Independent Audit

Southern Water Supply Storage – SSD 7089

Audit Number: 2

January 2024

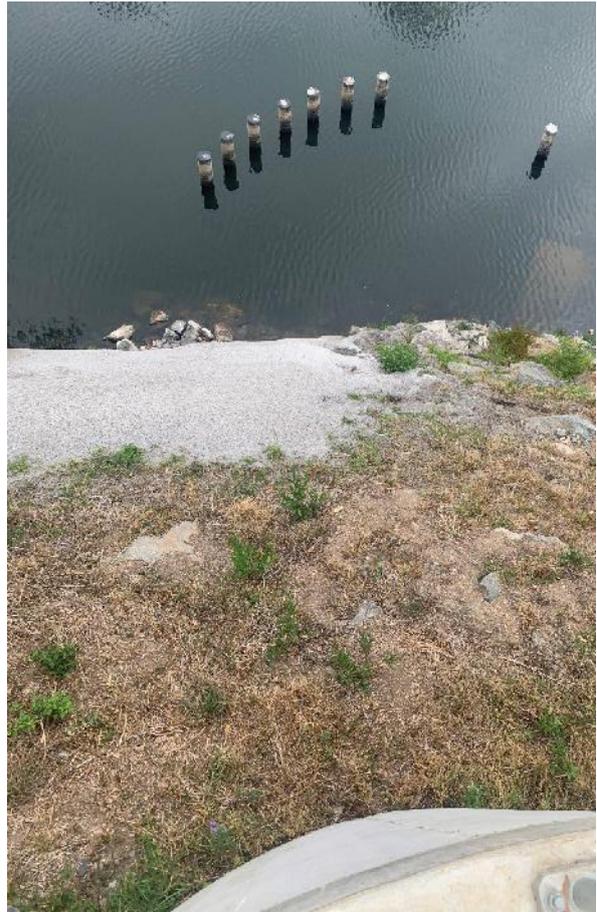
Wash bay sump with pipe bypass

Sump by-pass pipe drains to the ground 15-NOV-2023 (defeating the purpose of the concrete-lined wash bay and associated sump)

CORRECTIVE ACTION 21-NOV-2023 (noting wash bay not operational)

CORRECTIVE ACTION 21-NOV-2023 (adequate Dangerous Goods storage)
